**RE: Safety-Kleen Systems, Inc. Sanford; FLD 984 171 165, Operating Permit No. 22198-  
HO-005, Seminole County  
First Notice of Deficiencies Dated December 16, 2013**

Safety-Kleen (SK) has prepared this letter in response to the above referenced letter from the Department dated December 16, 2013. We have identified each of the Departments comments in bold, followed by our response. Revised pages of the application are enclosed with this submittal.

FIGURE 8-1  
CONTAINER STORAGE AREAS  
SAFETY-KLEEN SYSTEMS, INC.  
SANFORD, FLORIDA

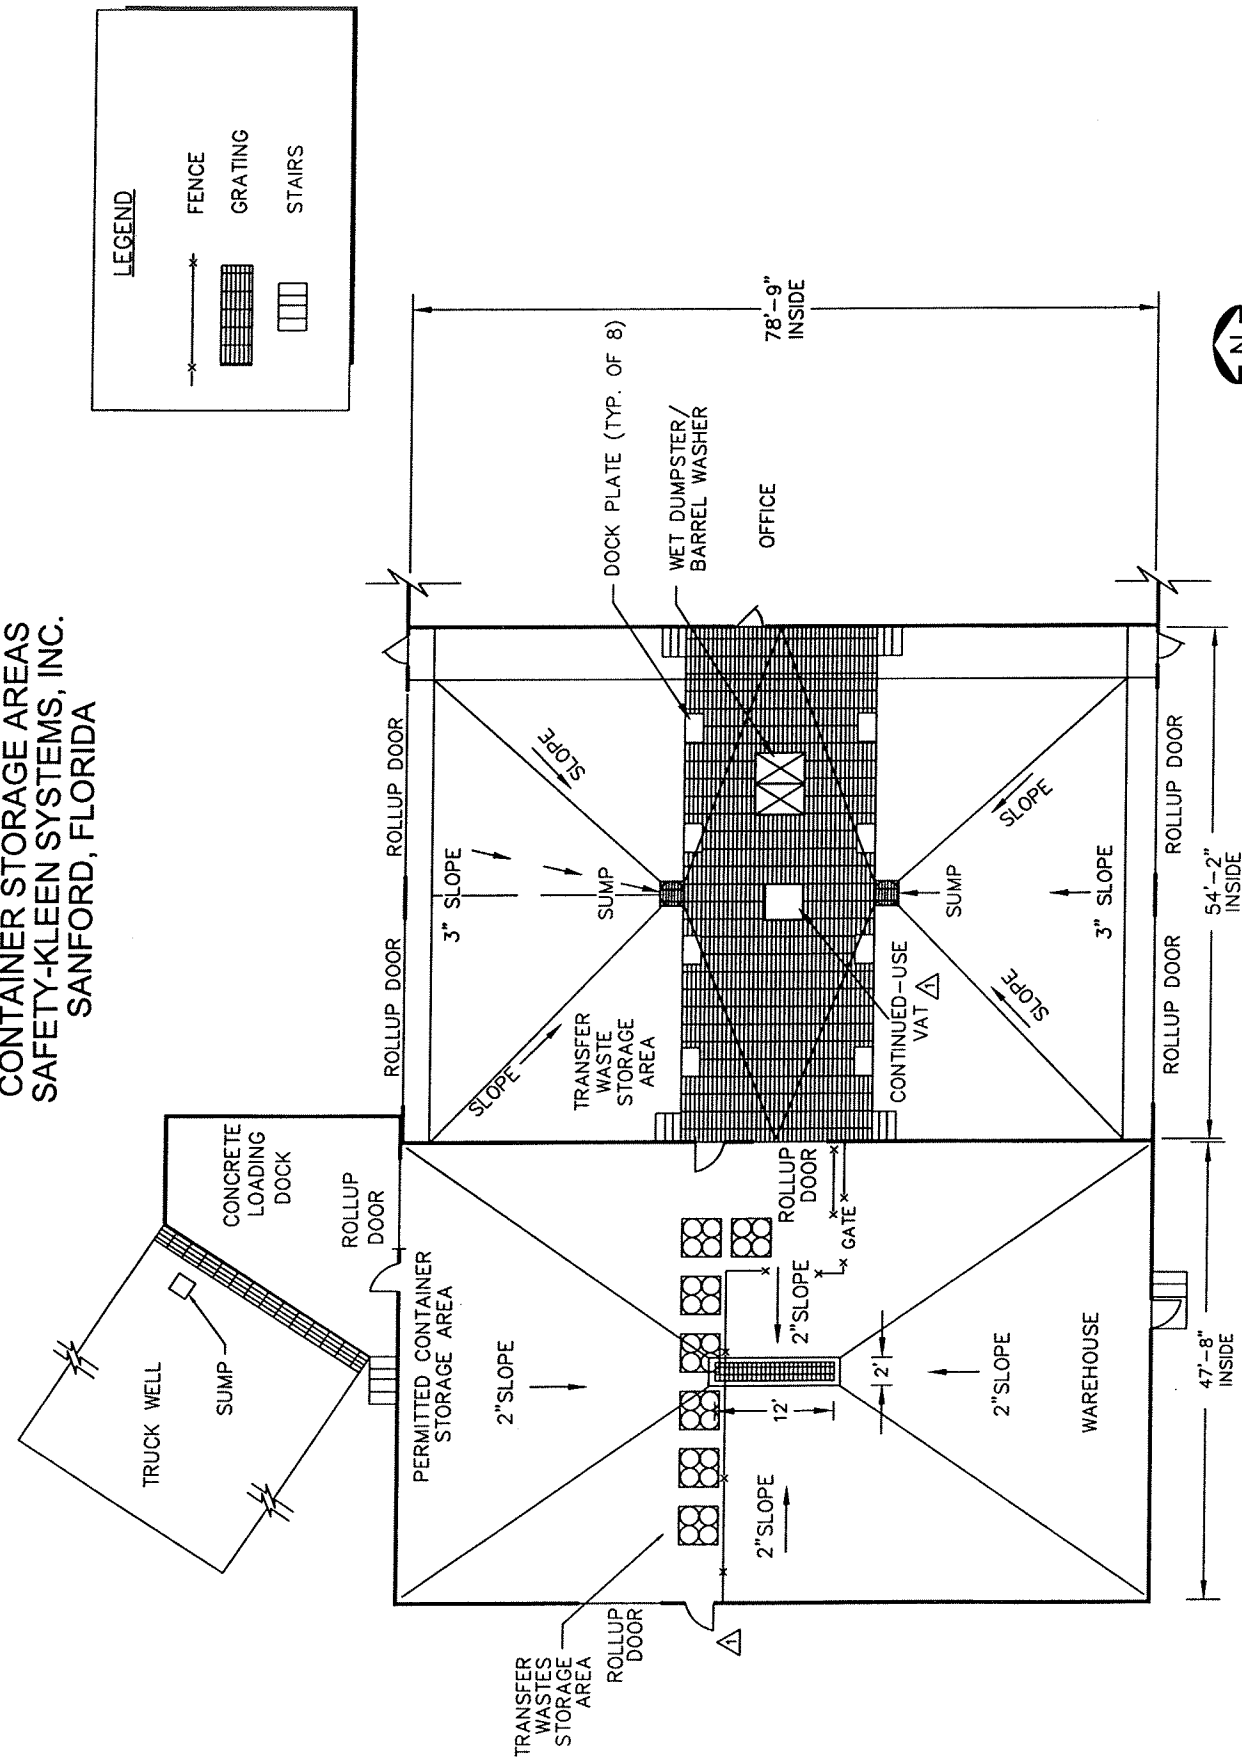
**FDEP Comments #11:** Part II.B Containers, Page 1, paragraph 2: This paragraph refers to a Figure 8.1-1 that is not included. Also the dimensions appear to be inconsistent. The text has a length of 47’ 7” but Figure 8-1 shows a 48’ 3” length, and the width is not noted on the figure. Be consistent with the labeling of figures. Need to label the containment calculations as Figure 8-2 to be consistent with the text.

*SK Response:* The above revisions have been made.

The container storage area (47' 8" x 34' 1") shown in Figure 8-1 occupies the northwestern portion of the warehouse (47' 8" x 78' 9"). This warehouse area has concrete floors, and a central collection trench to form a spill containment system within the area.

FIGURE 9.3-1  
RETURN/FILL SHELTER  
SAFETY-KLEEN SYSTEMS, INC.  
SANFORD, FLORIDA

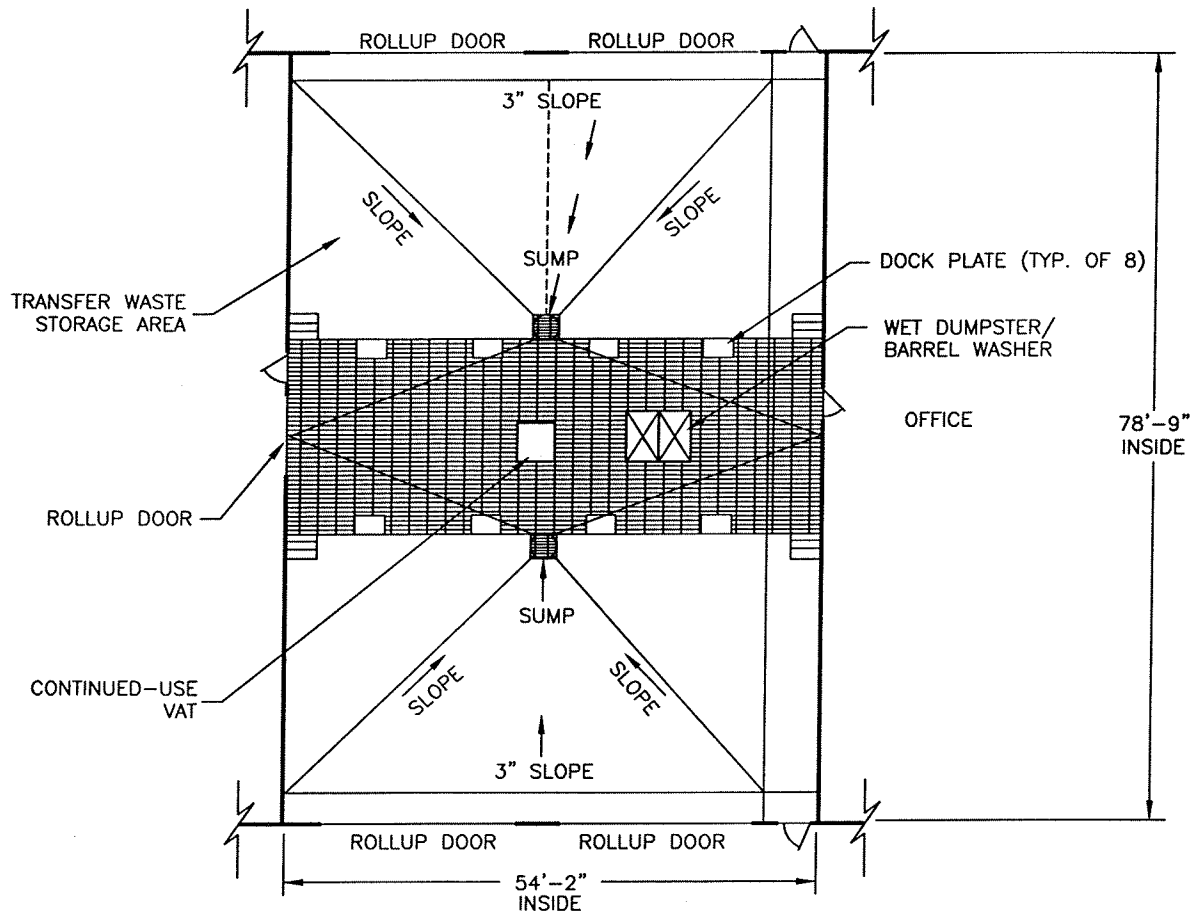
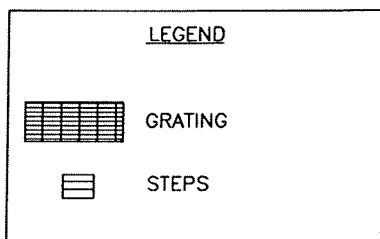
**FDEP Comments #15:** Page 5, paragraph 2: The length of the return/fill containment is given as 78' 9" here in the text but is 78' 1" on Figure 9.3-1. Correct the discrepancy here and elsewhere.

*SK Response:* These discrepancies have been corrected.

The return/fill station is a 54' 2" x 78' 9" structure (Figure 9.3-1) located between the office building and warehouse. It contains two wet dumpsters which handle the flow of waste solvent to the hazardous waste storage tank. These dumpsters are not intended for storage but can hold a maximum of 216 gallons (108 gallons per dumpster).
